<b>AMENDMENT OF SOLICITATION/MODIFICATION OF CONTRACT</b>			1. CONTRACT ID CODE	PAGE 1	OF 1	PAGES 1
2. AMENDMENT/MODIFICATION NO. <b>Amendment # 1</b>		3. EFFECTIVE DATE <b>03JUL13</b>	4. REQUISITION/PURCHASE REQ. NO. <b>N/A</b>	5. PROJECT NO. (If applicable)		
6. ISSUED BY <b>NASA DRYDEN FLIGHT RESEARCH CENTER PO BOX 273/D-1422/A/JMH EDWARDS, CA 93523-0273</b>		CODE	7. ADMINISTERED BY (If other than Item 6)		CODE	
8. NAME AND ADDRESS OF CONTRACTOR (No. Street, county, State and ZIP: Code)  <b>TO ALL BIDDERS</b>				(X)	9A. AMENDMENT OF SOLICITATION NO. <b>NND13458127E</b>	
				X	9B. DATED (SEE ITEM 11) <b>June 18, 2013</b>	
					10A. MODIFICATION OF CONTRACT/ORDER NO.	
					10B. DATED (SEE ITEM 13)	
CODE		FACILITY CODE

NASA DRYDEN FLIGHT RESEARCH CENTER  
 SOLICITATION # NND13458127E  
 REPAIR PRIMARY ELECTRICAL DISTRIBUTION SYSTEM - PHASE VIII  
 JOB WALKSITE VISIT  
 SIGN-IN SHEET

**RESPONSES TO SUBMITTED QUESTIONS**  
**AND**  
**ADDITIONAL CLARIFICATIONS/CORRECTIONS TO THE BID DOCUMENTS**

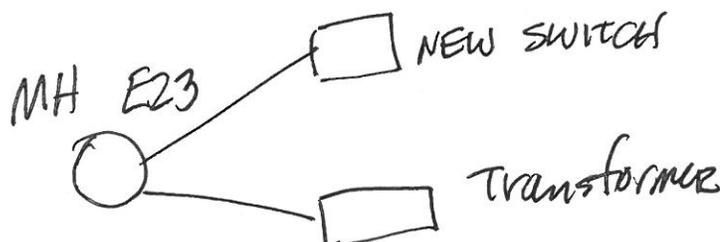
**QUESTION 5:**

Sheet/Detail – E3

No future conduits are shown stubbed out of the new 5 way switch, only the source in and one load to the existing transformer. Are future stubs to be installed?

Need to provide 5 – 5" conduits from the new 5 way switch to the MH E23. No conduits from the transformer to the new 5 way switch. The existing transformer feed will route through MH E23 to the new 5 way switch.

Repair Primary Electrical Distribution Phase VIII- Sketch 1

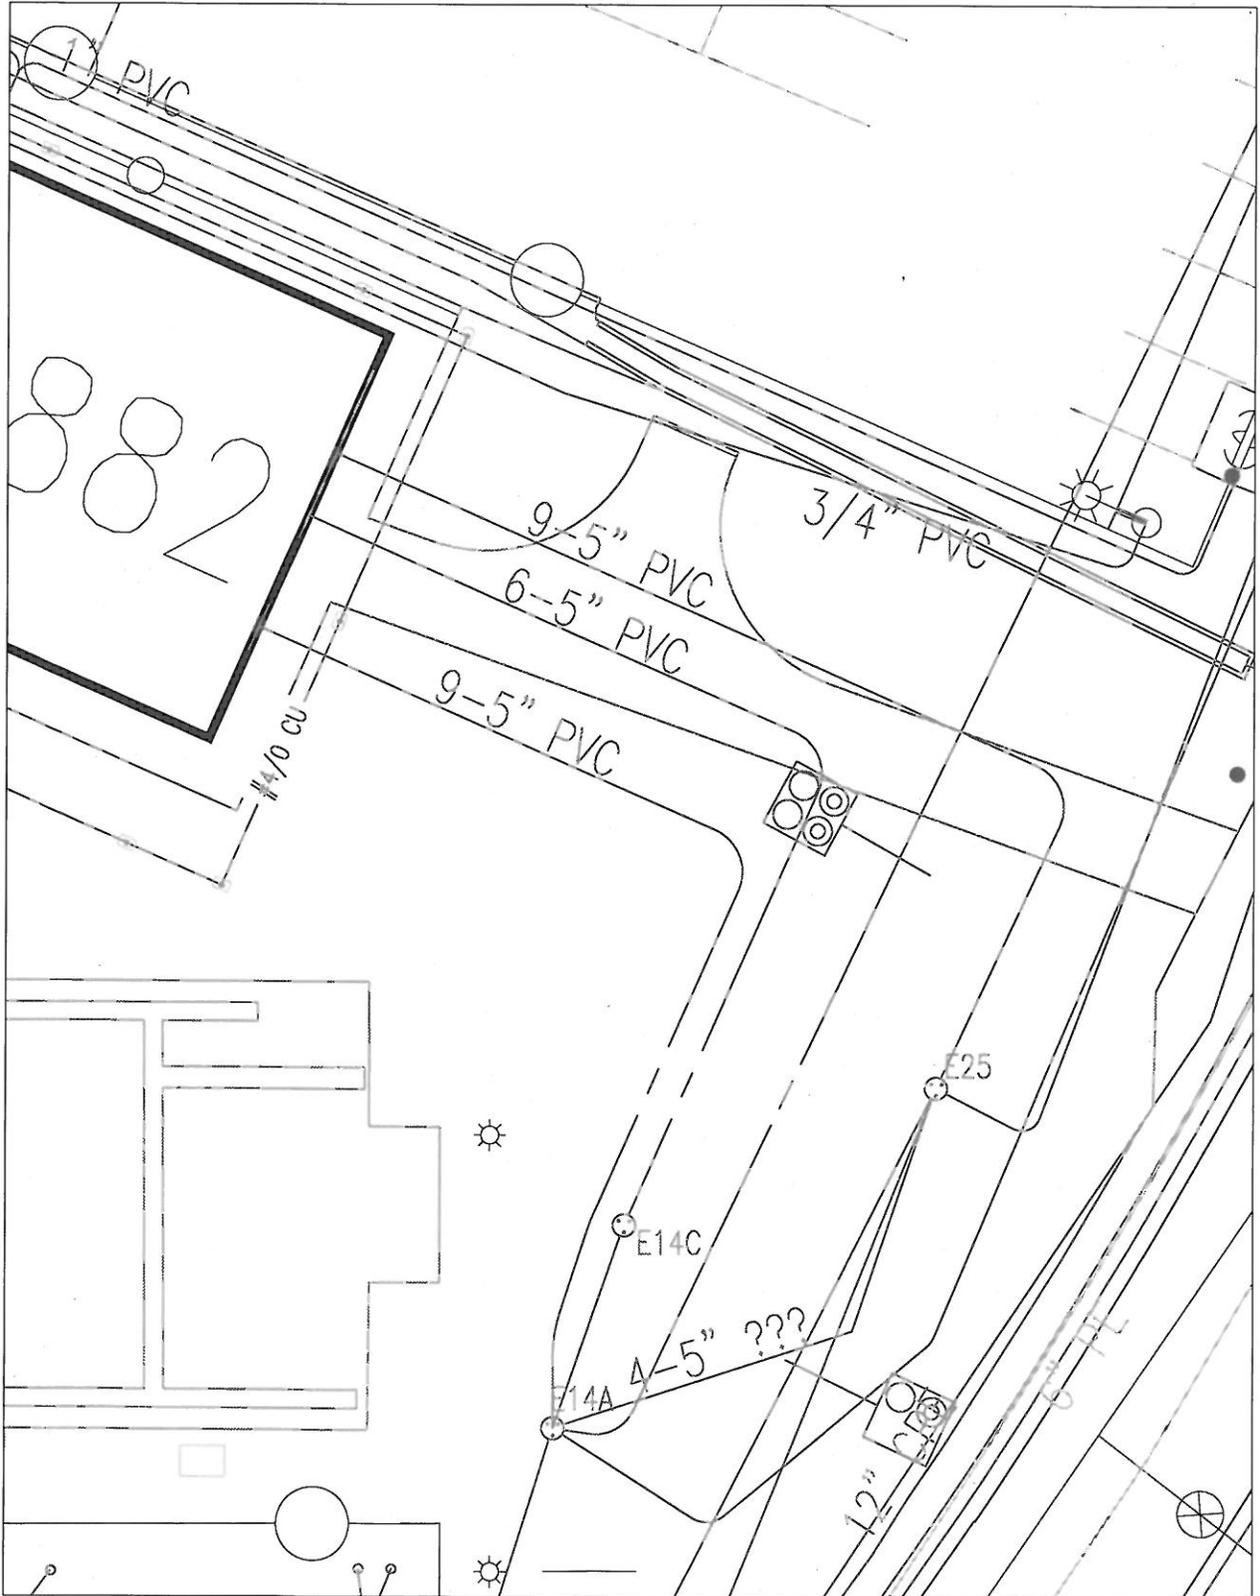
**QUESTION 8:**

Sheet/Detail – E9

Conductors with tags 5, 6, 9, 10, 11, 12, 15, 16, 17, and 18 all reference replacing cable from a PEDC breaker to each different load, but there are no homeruns shown from manholes E14A or E25.

Please provide the routing or lengths of the homeruns from manholes E14A and E25 to the PEDC breakers.

**ANSWER 8:**

See attached revised dwg.

ANSWER TO QUESTION #8.
